Section 4.55 (2) Modification Report

For Modification to Development Application No. DA/627/2018

Residential Flat Building
23-29 Harvey Avenue, Moorebank NSW 2170

Project 21-038
08 June 2023
Revision C

Figure 4: Shadow diagram

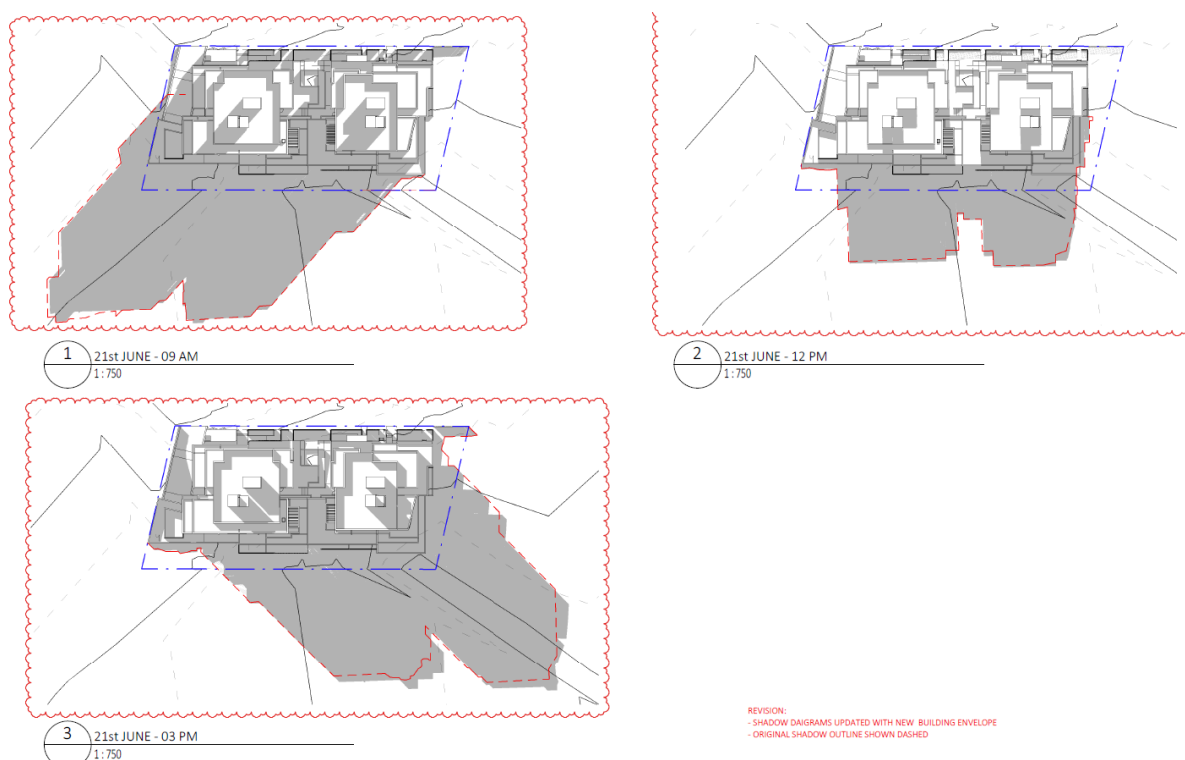
The proposed modification has increased height of building by 0.4m that will give rise to minor increase in overshadowing of the surrounding developments to the southeast in the afternoon.

The shadow study below shows the difference between the shadow as per the consented development and modified development. The study demonstrates that shadow impacts arising from parts of the building due to the minor increase of height are almost imperceptible.

Figure 14: Proposed South Elevation

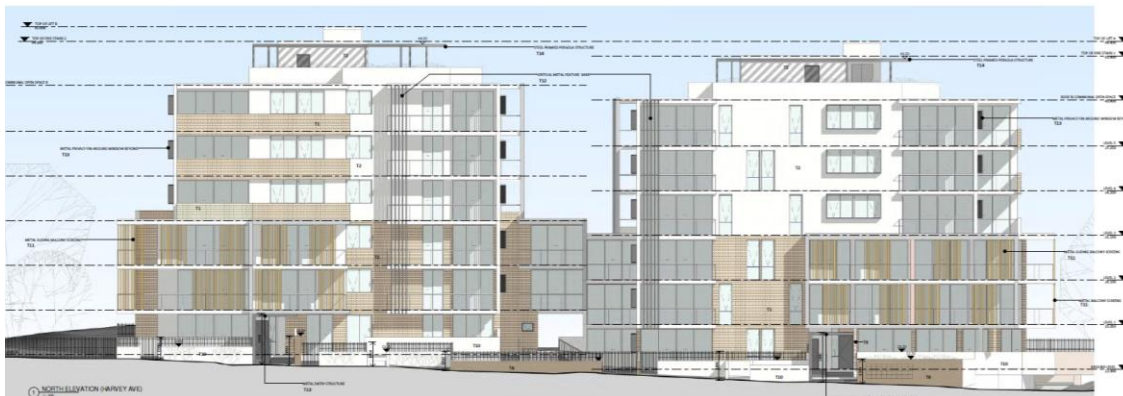
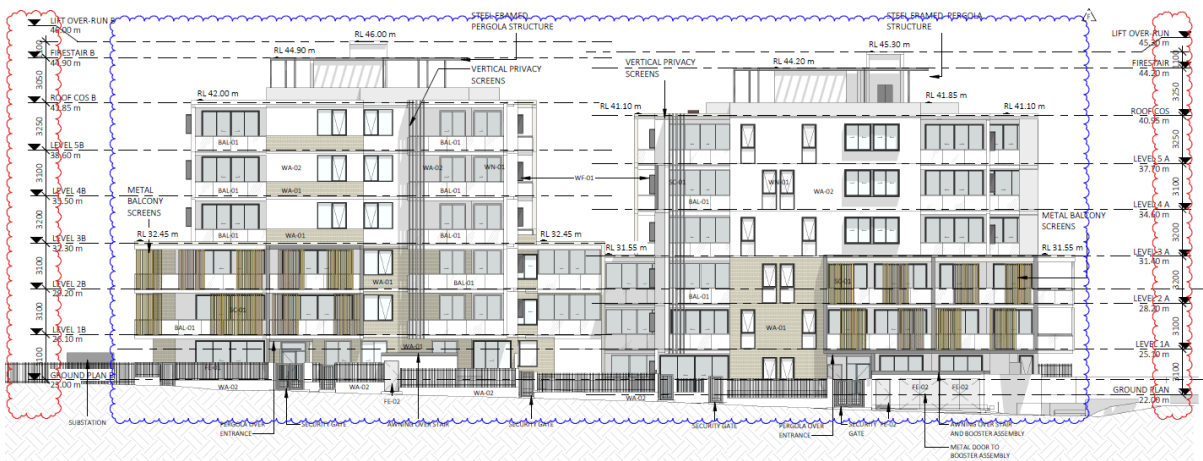
The proposed modification to the minor height increases in comparison to the consented design gives rise to no increase bulk and scale. Refer to the comparison below.
